UNITED STATES PATENT AND TRADEMARK OFFICE

APPLICATION NO.	FILING DATE	FIRST NAMED INVENTOR	ATTORNEY DOCKET NO.	CONFIRMATION NO.
10/060,945	01/30/2002	John C. Carrick	2376.2004-000	7237
21005 7590 08/30/2007 HAMILTON, BROOK, SMITH & REYNOLDS, P.C. 530 VIRGINIA ROAD P.O. BOX 9133 CONCORD, MA 01742-9133			EXAMINER KIM, DAVID S	
			ART UNIT 2613	PAPER NUMBER
			MAIL DATE 08/30/2007	DELIVERY MODE PAPER

Office Action Summary

DETAILED ACTION

FIG. 4A

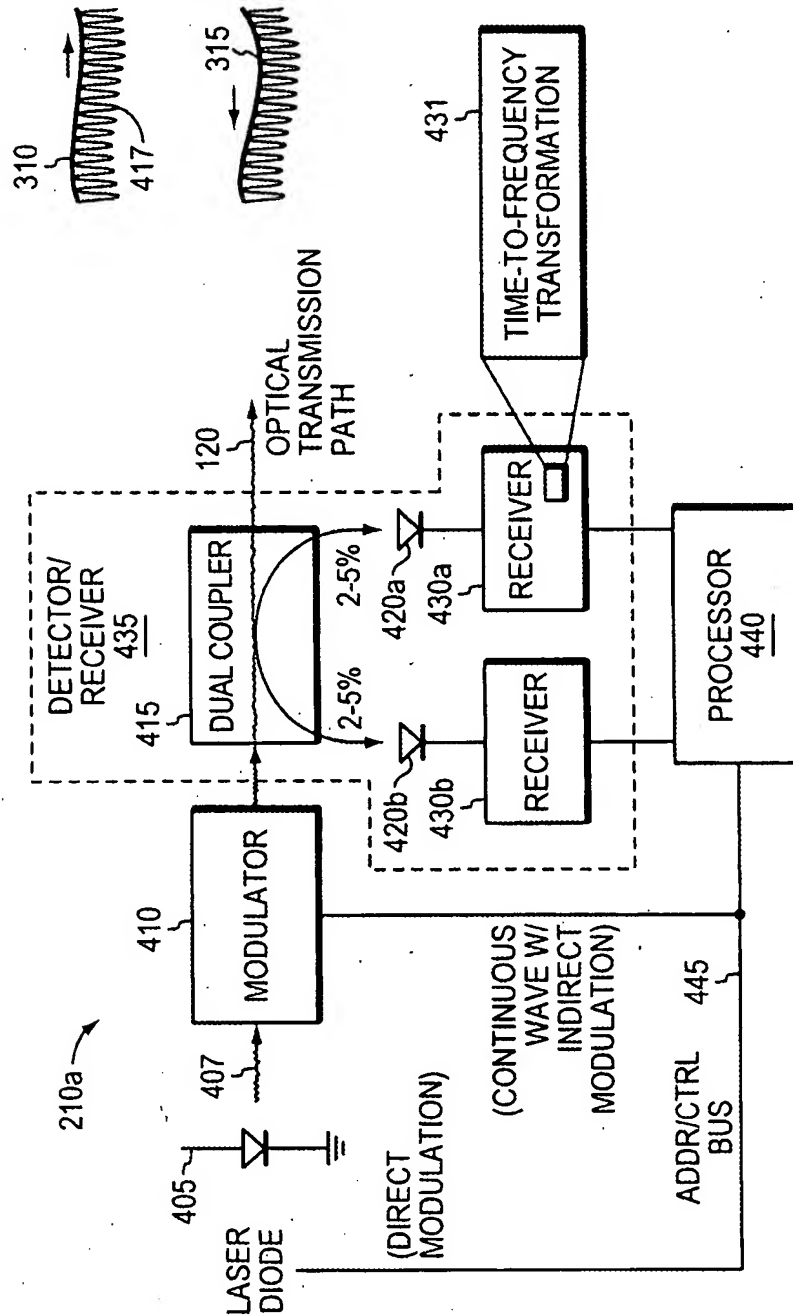
In Fig. 4A, component 431 was absent in previous versions of the drawings. Moreover, the original disclosure does not support component 431. Accordingly, component 431 constitutes new matter. That is, the disclosure teaches the use of time-to-frequency transformation by narrow band digital filters (p. 22, l. 12-15). Such digital filters are in the processor 440 (p. 22, l. 4). As a remedy, Examiner respectfully suggests the movement of component 431 from receiver 430a to processor 440.

FIG. 4D

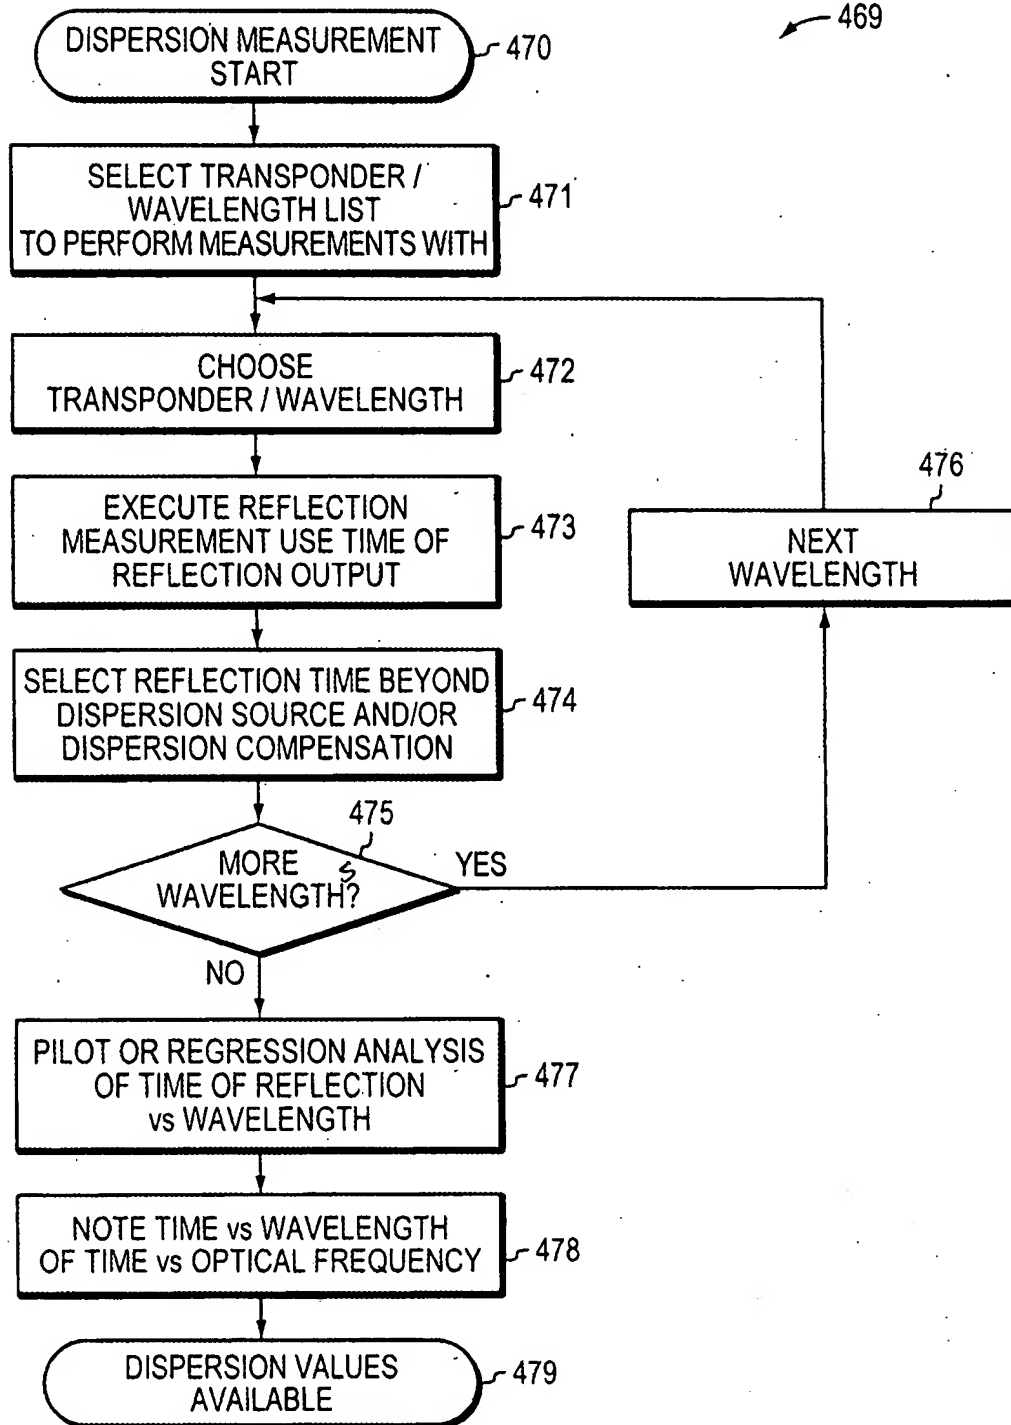
In Fig. 4D, step 475 may be intended to be "MORE WAVELENGTHS" instead of "MORE WAVELENGTH". See original drawing Fig. 4D filed on 30 January 2002.

FIG. 7

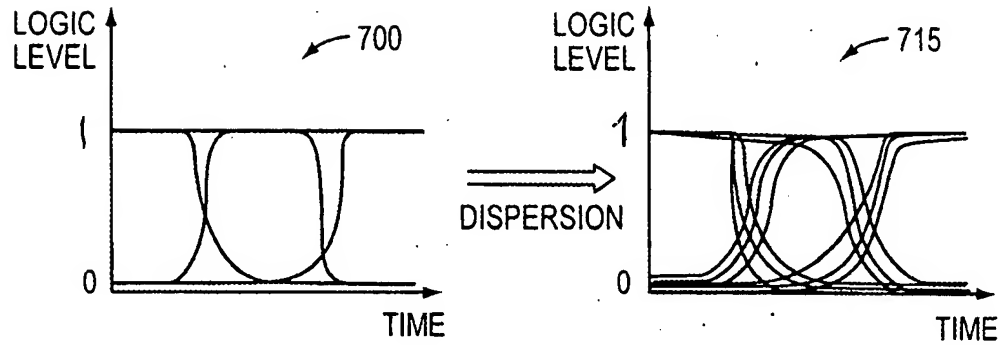
In Fig. 7, the diagrams are missing the logic level indicator "1" for the vertical axis. See original drawing Fig. 7 filed on 30 January 2002.
